Designer's Response

Project	Land West of Allbrook Way, Allbrook
Project Number	23823
Comments Received from	Hampshire County Council LLFA Team dated 15 November 2024 Ref SWM/2024/0622
Date Comments Received	21 November 2024
Date of Response	25 November 2024

CLIENT	Bargate Home		
PROJECT	Knowel Hill Albrook Eastleigh		
TITLE	Proposed Drainage Layout Plan Whole Site		
DRAWN	DATE	PROJECT NO.	
M Pacifico	Oct 2024	23823	
ENGINEER	CHECKED	DWG NO.	REV
S Magowan		200	C
SCALE	1:500 @ A1

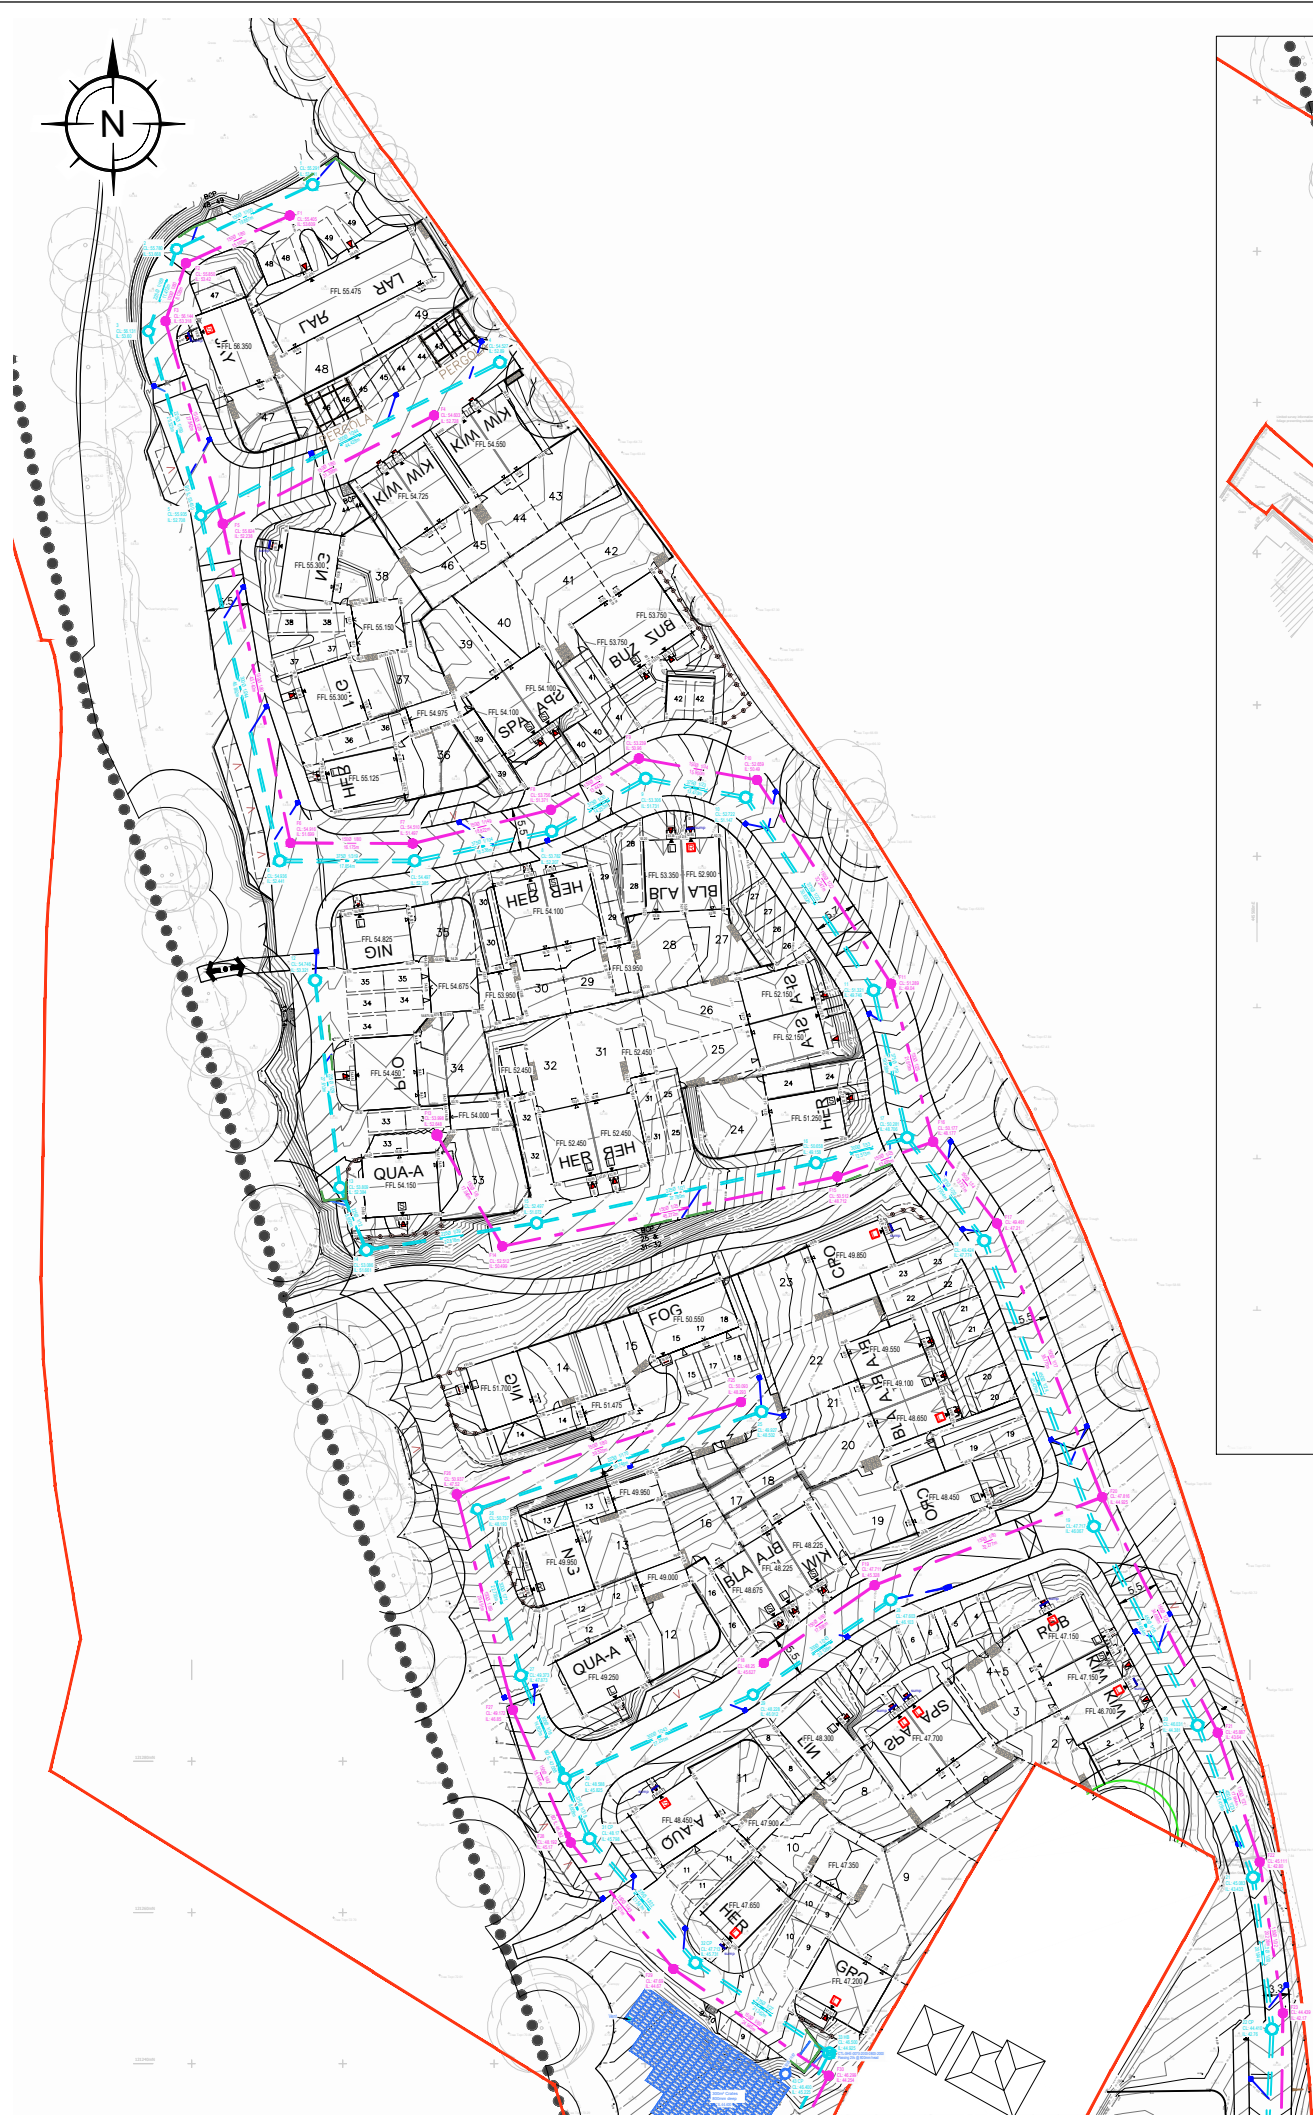
Comment / Query from LLFA	Designer's response
2 Both of the offline attenuation tanks, as shown on the proposed drainage layout plan, are shown at a level lower than the carrier drain. After a significant storm event in which the attenuation tanks are filled with water, they will not be able to drain fully, back into the network. As the tanks are to be lined, this water will remain in the tanks, reducing the available capacity for the next storm event. For example: the attenuation tank upstream of node 33, has tank invert level labelled as 44.40, the downstream node invert level node 33 is labelled as 44.925. based on pipe lengths and gradients shown in the drawing the invert level of the outlet pipe from the attenuation tank is estimated to be approximately 45.00, the tank is 0.8m depth, following a storm event in which the tank is filled with water, only the top 0.2m of the tank will be able to empty back into the carrier drain network, the remaining 0.6m depth of water will remain trapped in the tank. Raising the tank design level above the invert level of the carrier network could cause the tank to break ground level in the southern corner. The model does not detail the offline storage but rather assigns a storage volume to the nearest downstream node where the hydrobrake is located and therefore this issue is not shown in the modelling results. Consideration should be given to access to the attenuation tanks for inspection and maintenance. Consideration should be given to venting of the attenuation tanks to allow escape of air while the tanks are filled with water. The LLFA has concerns that this design flaw could present an increased risk of flooding to the existing dwellings and to the highway close to the location of the proposed attenuation tanks.	Noted, this is an error. Revised drawings 200C, 201C, 202C and 203C are attached. The crate invert levels are set approximately 50mm higher than the downstream node (manholes) to allow the storage to drain. Ground levels have been adjusted to suit and ensure the crates have suitable cover and are as shown on attached drawings 400E, 401C, 402C and 403C. The point on maintenance is noted and we confirm the manholes upstream of the storage tanks are designed as catchpits to capture silt and debris. This together with maintenance as noted in the maintenance schedule will prevent any debris and silt entering the storage area. A further catchpit at the crate entrance has been added to allow inspection of the crates. The storage crates will be vented and a note has been added to the drainage plans.

Comment / Query from LLFA		Designer's response
6	The proposed location of the downstream defender treatment device is not clear on the drainage drawings. Data sheets containing the pollution mitigation indices for any proposed proprietary treatment devices should be submitted.	The location of the Downstream Defeder is clarified on the attached drainage drawings. The data sheet which details the pollution mitigation indices is also attached.
7	A review of the Drainage Management and Maintenance Schedule is required. Regular maintenance of storage structures is not mentioned, consideration should be given to removal of silt or blockages from the storage structures as required. The LPA should confirm they are satisfied with the proposed arrangements for future maintenance of the drainage infrastructure being the ultimate responsibility of the future homeowners.	The design together with the Drainage Management and Maintenance Schedule details the areas of maintenance required and notes for the storage structures Corrective Maintenance - Reconstruct storage structures if performance deteriorates or failure occurs (as required) Monitoring - Inspect storage structures to ensure they are fully emptying (annually) The regular maintenance of the upstream catchpits, inlet chambers and pipe network will prevent any silt and debris entering the system and is detailed in the schedule. As noted in the response to 2 above catchpits to allow inspection of the storage crates have been added.

CLIENT		Bargate Home	
PROJECT		Knowel Hill Albrook Eastleigh	
TITLE		Proposed Levels Layout Plan Whole Site	
DRAWN	DATE	PROJECT NO.	
M Pacifico	Sept 2024	23823	
ENGINEER	CHECKED	DWG No.	REV
S Magowan		400	E
SCALE	1:500 @ A1

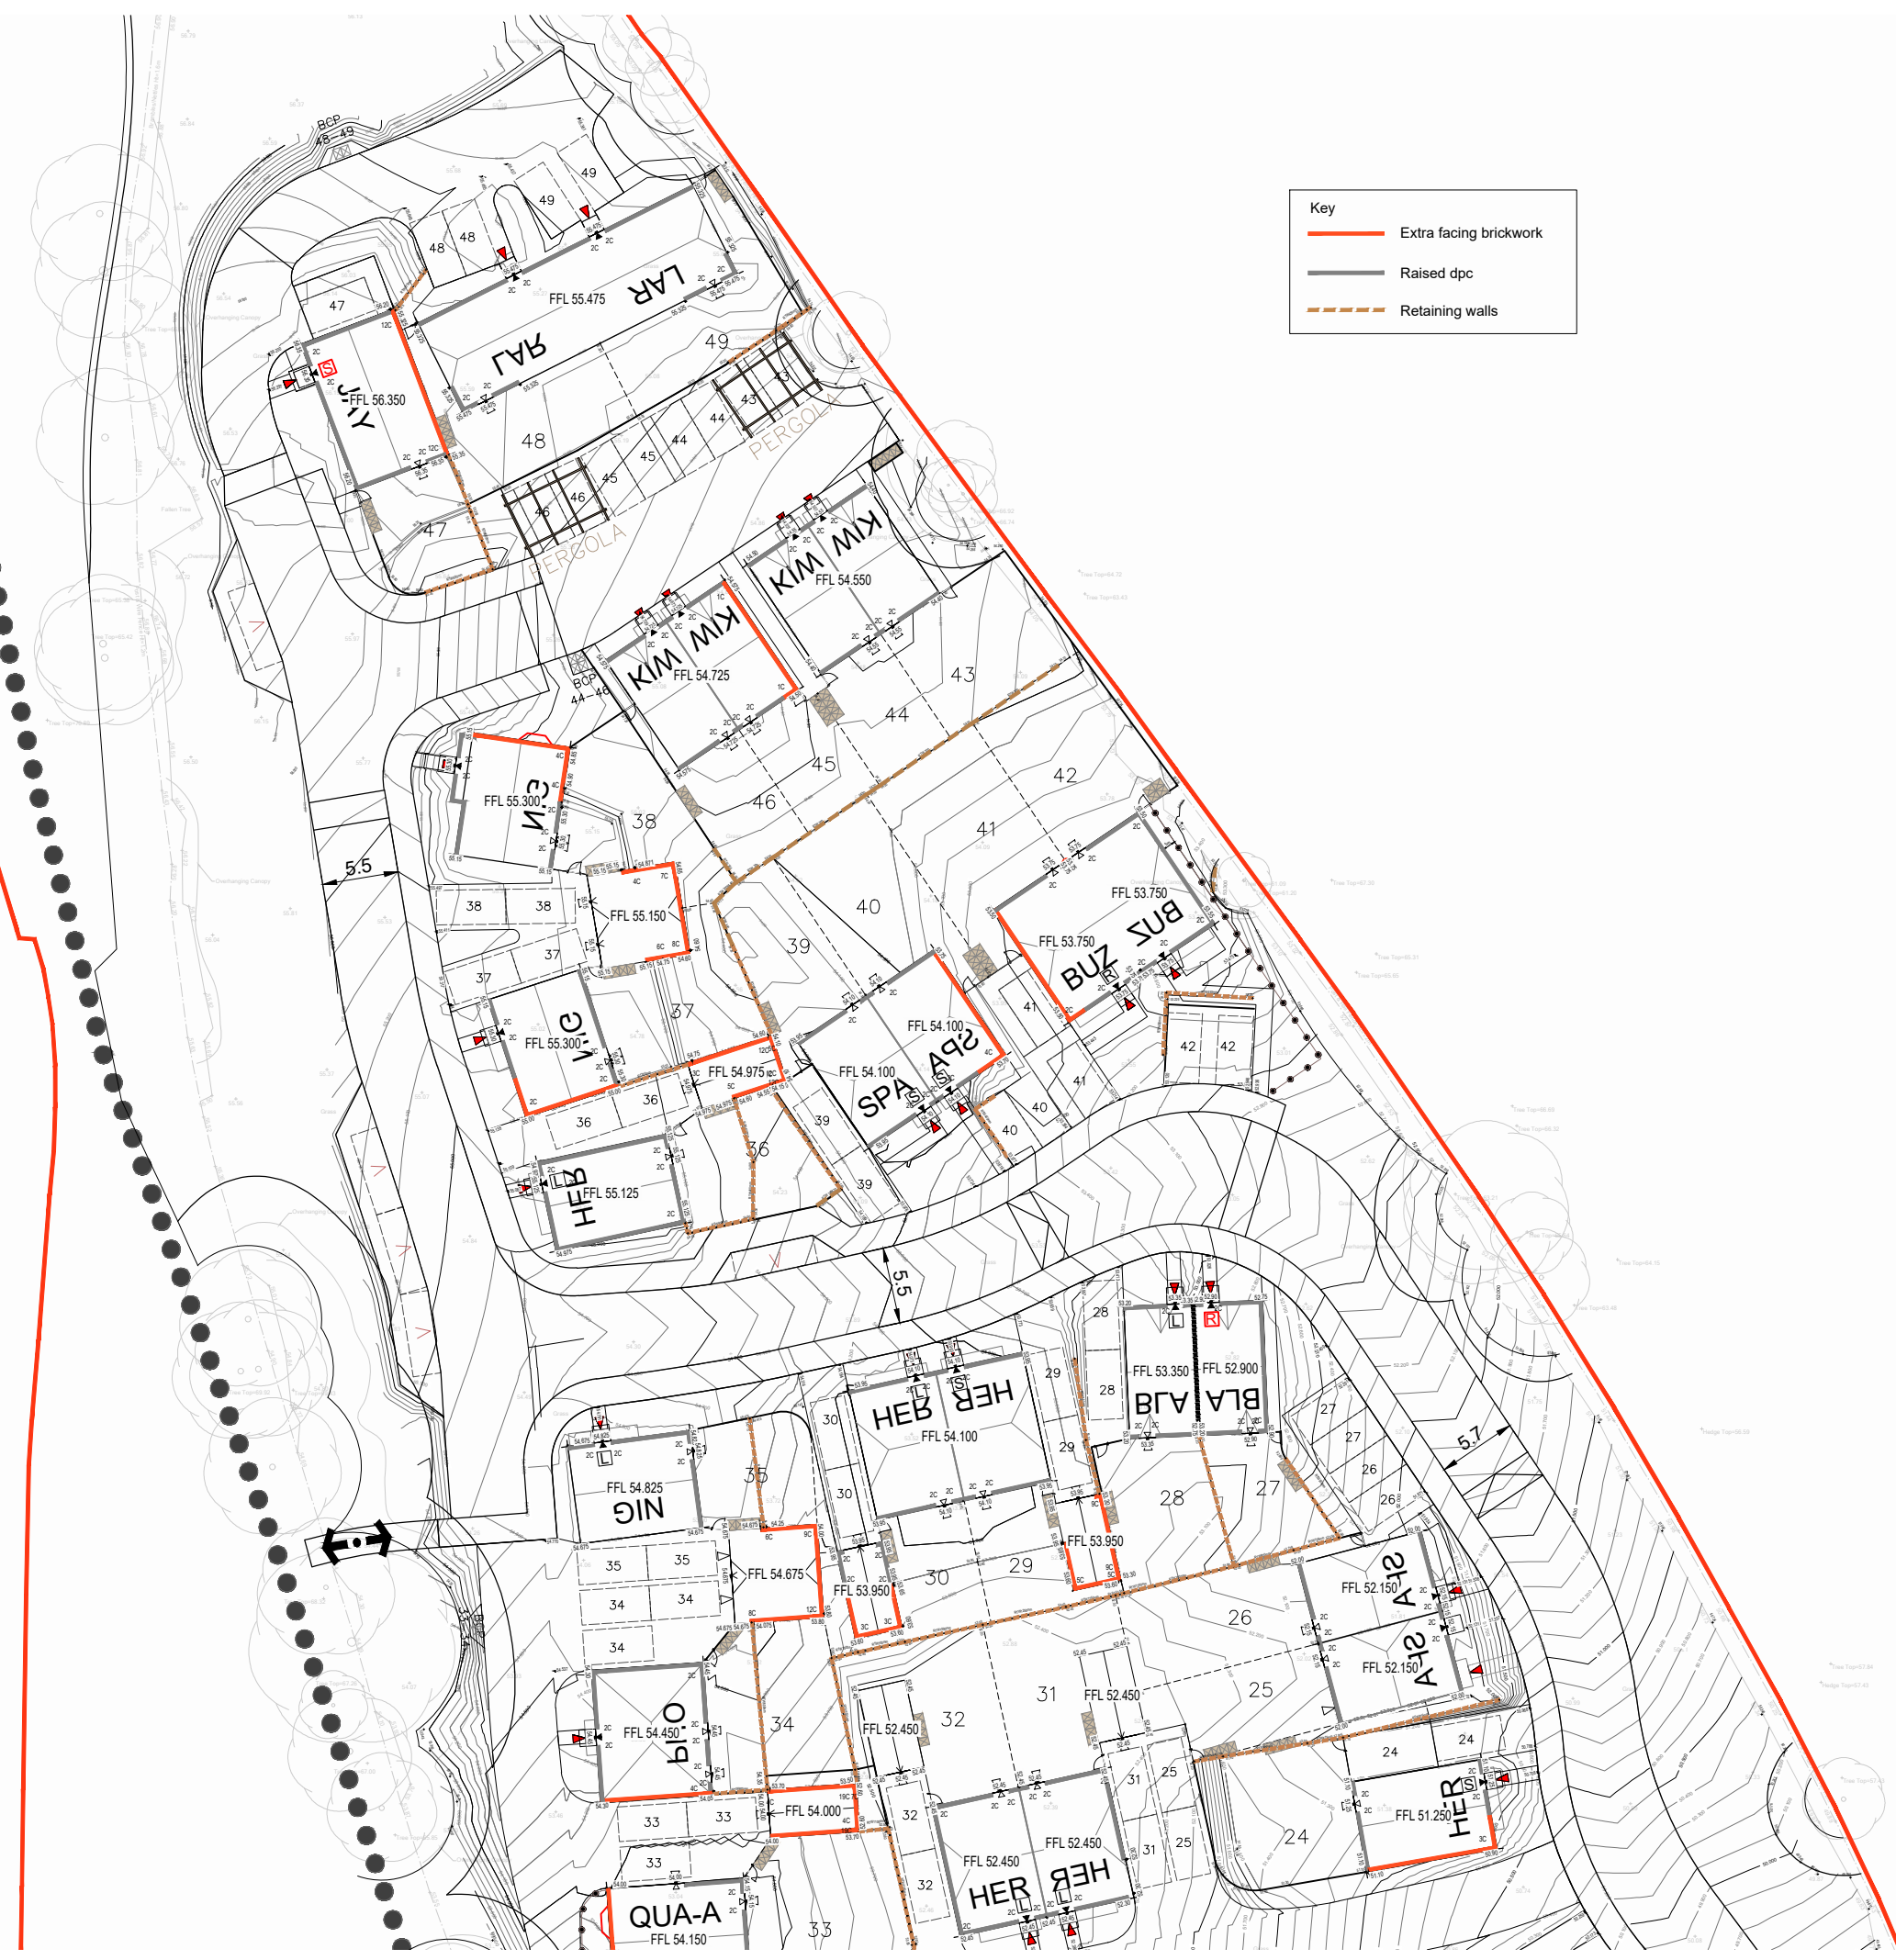
Comment / Query from LLFA		Designer's response
10	There are inconsistencies between the exceedance flow route plan and the proposed levels plan in the northern section of the site. It must be demonstrated that the design levels will direct exceedance flow away for proposed dwellings.	This point will need to be more specific. There are no inconsistencies. Flows are directed away from dwellings. Permeable paving areas have low points that direct any exceedance to soft landscaping or onto the main access and main routes all direct surface water to soft landscaping and away from dwellings.
